DISCUSSION

Minimum Confinement Reinforcement for Prestressed Concrete Piles and a Rational Seismic Design Framework

The following comments relate to “Minimum Confinement Reinforcement for Prestressed Concrete Piles and a Rational Seismic Design Framework,”¹ by S. Sritharan, A.-M. Cox, J. Huang, M. Suleiman, and K. Arulmoli, which appeared in the January–February 2016 issue of *PCI Journal*.

FIGURE 2.

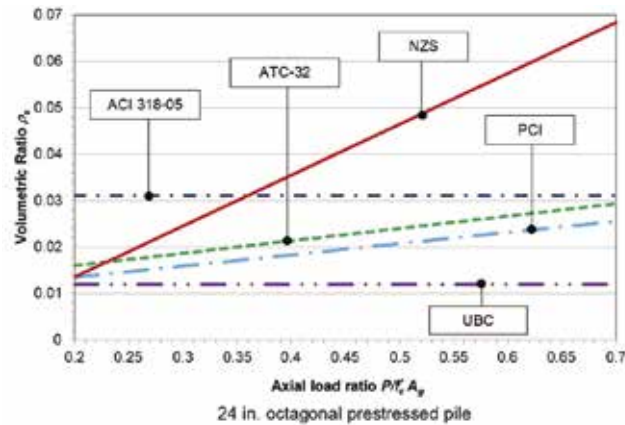
The *Uniform Building Code* requirements⁵ shown in the paper must have a misprint because it says that the minimum spiral steel ratio is 0.021 for all sizes. **Figure 2** shows 0.021 for the 14 in. (360 mm) square pile and a smaller value, perhaps 0.012, for the 24 in. (610 mm) octagonal pile.

- The variable ϕ in Eq. (5) of the manuscript defines the strength reduction factor; a value of 1.0 was used when finding the confinement reinforcement quantities for comparison with those obtained from other recommended equations.¹
- For a detailed description of Eq. (5), the reader is referred to NZS 3101.^{11,12}
- The UBC requirements should read as follows: $\rho_s \geq 0.021$ for piles 14 in. (360 mm) and smaller; and $\rho_s \geq 0.012$ for piles 24 in. (610 mm) and larger.¹³
